Wiltshire Council Planning Consultation Response

9 February 2026

Application No: PL/2026/00822 and PL/2026/00550
Retrospective planning application for rear dormer/balcony alteration, solar panels, rooflights and variations to rear elevation construction. MOORFIELD FARM, 2 CHURCH STREET, STEEPLE ASHTON, TROWBRIDGE, BA14 6EW

Second floor plan

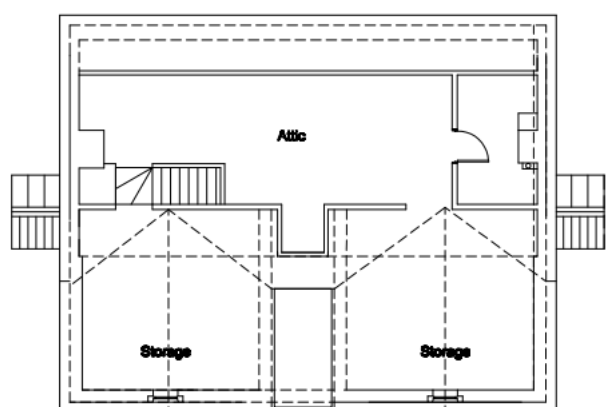
However, I note that there is no consent for the second floor to be used as habitable accommodation. As shown in the proposed floor plan submitted with the 2017 application:

As such I fail to see the need for any rooflights. Should this application be amended to include the use of the attic space as accommodation the Heritage Statement would need amending to make a detailed assessment of the impact of the proposal, including the impact of the services and pipe runs for the ensuite, partitions, finishes etc.

I note that the current Heritage Statement makes reference that none of the unauthorised rooflights have cut through any roof members, however the report does not include any

photographs showing the attic space. As such a detailed photographs survey of this area is requested showing each intervention carried out without consent – rooflights, ensuite, partitions, internal finishes etc.

As such the applicant is asked to either omit the proposed roof lights from this proposal or formally apply to regularise the use of the second floor as habitable accommodation to include bedroom and ensuite.
